October, 2021 Oriental Motor USA, Corp.

[Important Notice] Notice and Request Concerning the Safety of Our Motor Driver

- 1. Product of concern:Driver for brushless motor **BMU** Series 30W/60W/120W(For the identification method of the applicable product, please refer to 4. "How to identify
applicable product" on the next page)
- 2. Overview: The shaft that supports the dial (behind the dial) was found to be an electrified part because it is electrically connected to the internal circuit. Therefore, direct contact with the shaft may result in an electric shock if the front dial were to be removed and the driver has power. The driver is safe to use as intended with the dial attached. Please note that the products that we currently ship out are designed with the dial that will not come off.

[When the dial is removed]

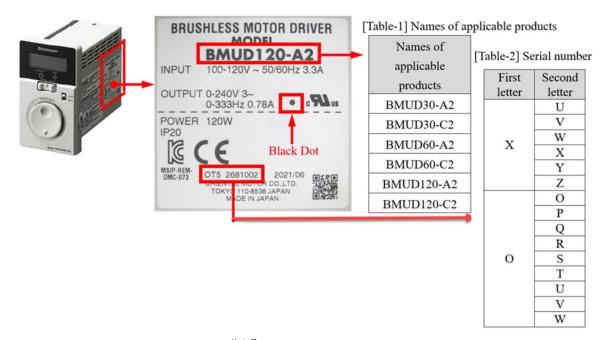
Safe to use, please DO NOT remove the dial and keep it in place while using.

If the dial comes off unintentionally, be sure to turn off the power.

When reattaching the dial, please wait for at least 1 minute after the power is turned off.
